SUBJECT: Single Phase, 4800 V Distribution line
replacement.

Reference No: 06212551/Chase Twp/Lake/Lyonnais

FIELD REVIEW FOR
COMPATIBLE USE OF RIGHT-OF-WAY
Request # CU-154

Tower # 4021

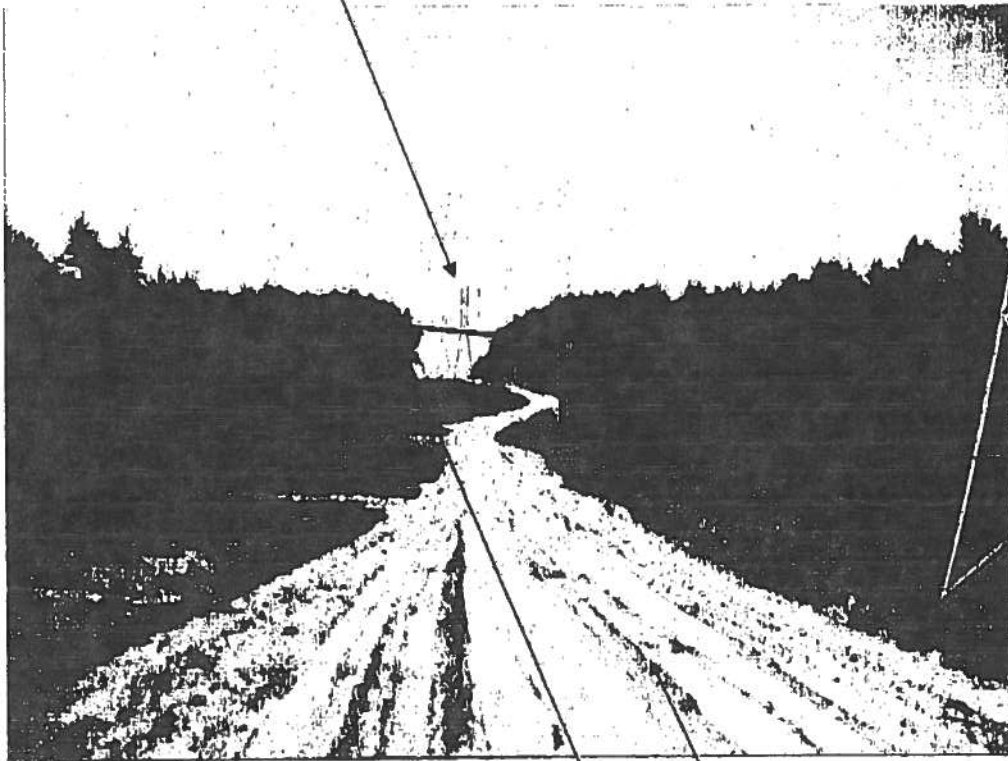
The proposed distribution line will be no closer than 37' from the centerline of the existing transmission line. The resulting horizontal clearance under a 6 psf wind is approximately 24'. NESC code (and CE Standards) requires a minimum of 3.5' between a 138 kV line and a distribution pole.

On the existing plan & profile drawing from CE, the existing 110 KCMIL copper conductor was plotted at 284° F. The pole height and class was provided by CE as being 40/6 poles. Using a typical embedment of 10% + 2' the distribution height is assumed to be at 34'. The resulting vertical clearance between the proposed distribution line and the existing conductor is approximately 3'. NESC code (and CE Standards) requires a minimum of 4.1' between a 138 kV line and a distribution line. See enclosed sketch.

Based on our field review and calculations, it is our recommendation that this line is not acceptable at this time in the proposed location.

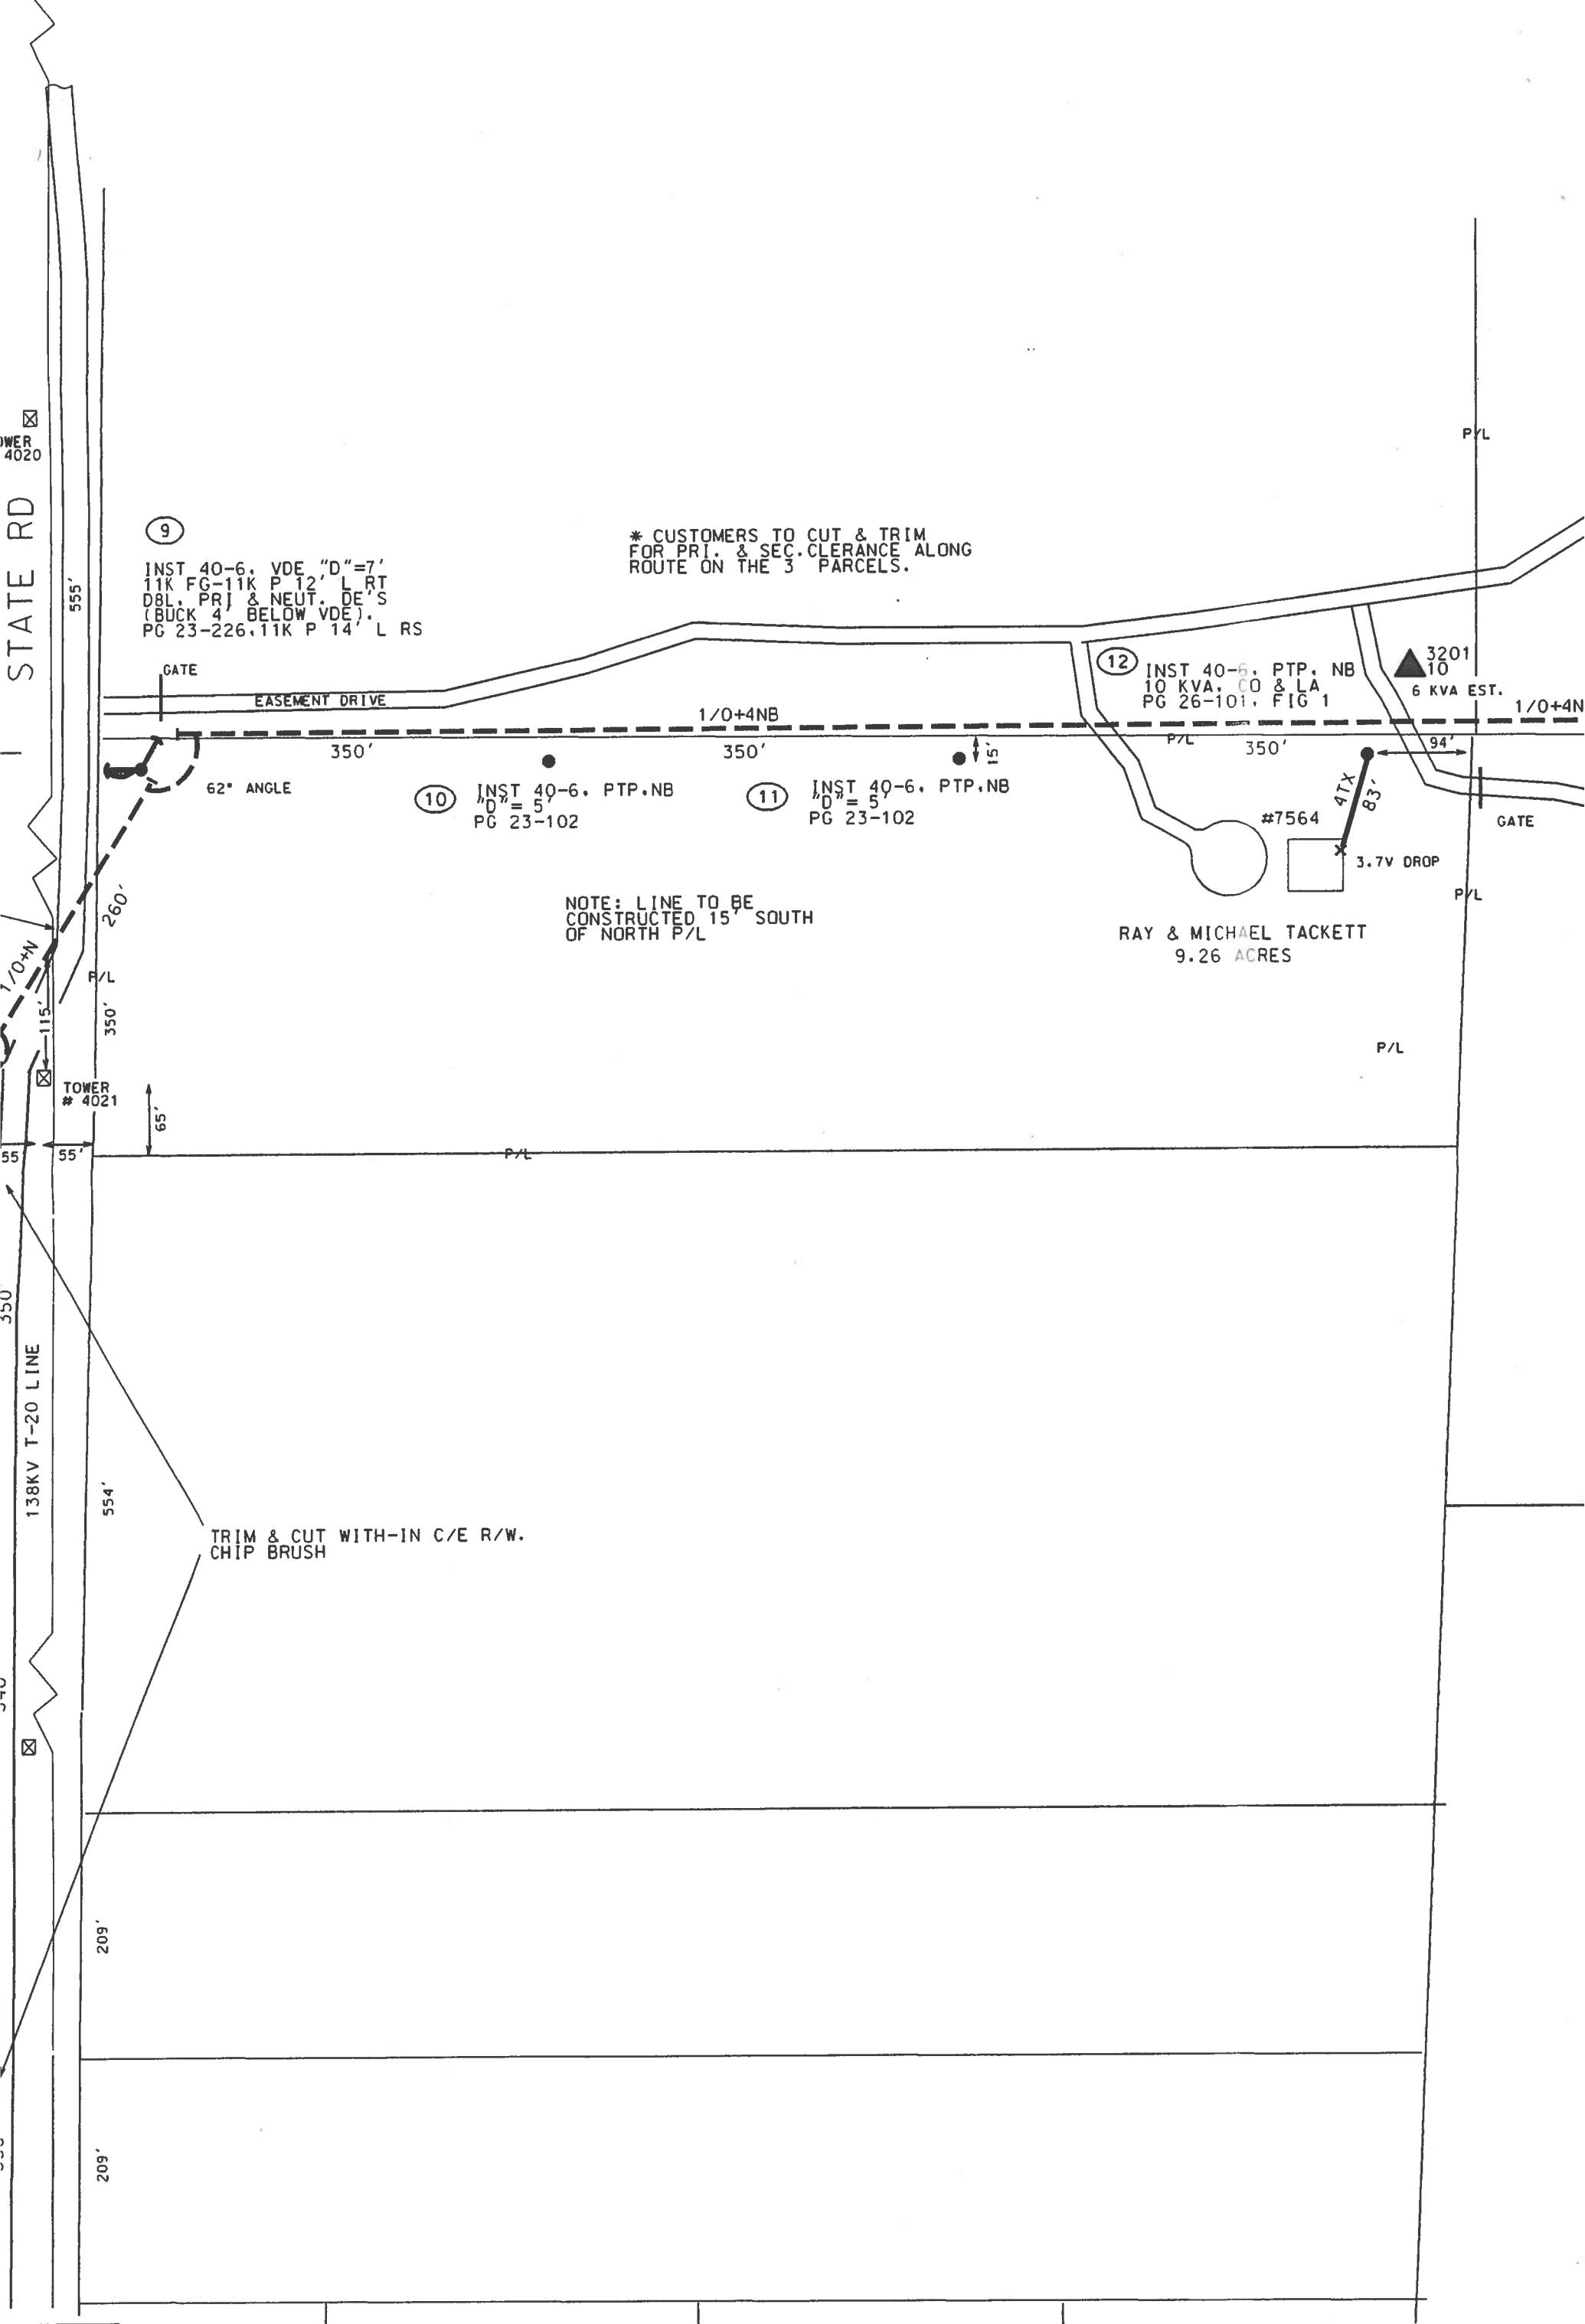
The METC transmission line was identified as Chase to Mecosta plant 138 kV line 1E. CE was proposing the installation of a distribution line that would parallel & cross under an existing transmission line. A field review of the plan was done on June 14, 2005. The conductor attachments elevations were field measured. The drawing TRS 171107 submitted by CE was accurate in depicting the existing situation.

The proposed distribution line will be no closer than 37' from the centerline of the existing transmission line. The resulting horizontal clearance under a 6 psf wind is approximately 24'. NESC code (and CE Standards) requires a minimum of 3.5' between a 138 kV line and a distribution pole.

On the existing plan & profile drawing from CE, the existing 110 KCMIL copper conductor was plotted at 284° F. The pole height and class was provided by CE as being 40/6 poles. Using a typical embedment of 10% + 2' the distribution height is assumed to be at 25'. The resulting vertical clearance between the proposed distribution line and the existing conductor is approximately 11'. NESC code (and CE Standards) requires a minimum of 4.1' between a 138 kV line and a distribution line. See enclosed sketch.

Based on our field review and calculations, it is our recommendation that this line is acceptable at this time in the proposed location.
